# Memorandum

**Date:** June 23, 2017 for meeting on June 27, 2017

**Re:** **MMC request for IOZ designation: Draft Institutional Development Plan (IDP)**

**Applicant:** Maine Medical Center (MMC)

**MMC REVISED HEIGHT SCENARIO /**

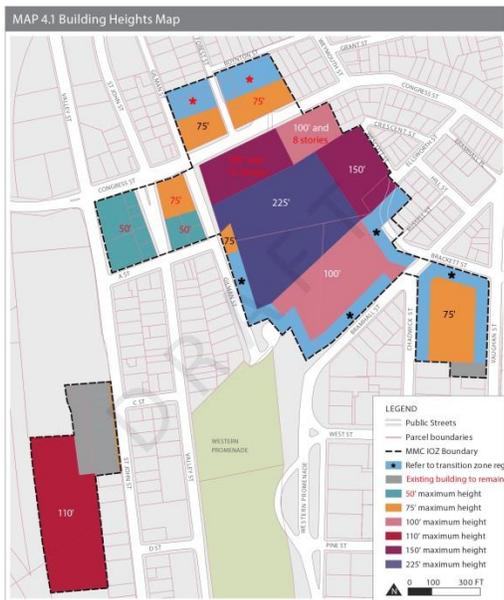
**Height:** Staff proposes revisions to the Height Map (see attachment Building Heights Map) towards new development that is compatible with the neighboring context scale, does not overwhelm the street, mitigates shadow impacts on residential properties and the street, and provides building footprints in a scale and orientation consistent with the downtown Congress Street corridor building patterns:

- Introduce building height minimums – 2 stories in transition zones, 3 stories everywhere else
- Concentrate height towards Congress Street and the center of the main campus block
- Introduce a building height maximums in stories - 12 and 8 stories on Congress Street (see image)
- Have 75’ six story buildings facing Congress Street
- Reduce the heights allowed on the A Street blocks to 50’ and 75’ – to transition to residential scale but also to provide a view transition uphill towards the main campus

**Transition Zones:** MMC is proposing 50’ deep transition zones on smaller streets such as Gilman, Forest, Boynton, and Weymouth in order to have building footprints that meet parking programmatic needs (see their presentation materials for street sections and view angles). Staff recommend that some of these proposed transition zones become deeper in width to mitigate the impact of 6-story buildings as well as to create taller building forms closer to Congress Street of similar size and footprint to the downtown Congress Street corridor (see attachment Building Heights Map).

- The two northerly blocks would have an R-6 transition zone of half a block
- The Gilman block would have 50’ transition for half a block
